FIELD OBSERVATION REPORT

Child Nutrition Building (Food Service Building, 202276 -CA8)

Report No: 23

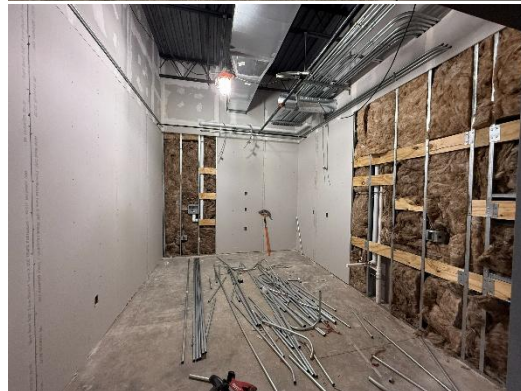
- e) Wallboard was being hung in the office area. It was not being finished because temporary heat was not started. Brad reported that temporary heat will be applied to the building on Monday, December 15. This will allow the finishers to tape and spackle the joints and spackle the screw heads.

- f) Control joints need to be installed in the wallboard at 30' on center from the slab to the top of the walls.

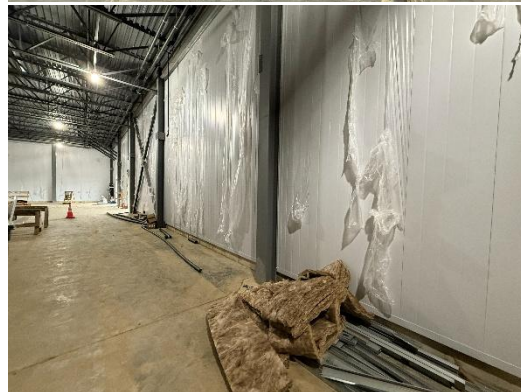
- k) Refer to the Field Observation Report from CMTA concerning making pipe insulation continuous through wallboard and through the walls.

- l) Batt insulation was being installed on the exterior walls that will be behind the freezer. The batts were set in place but the steel straps were not yet installed to hold them firmly in place.
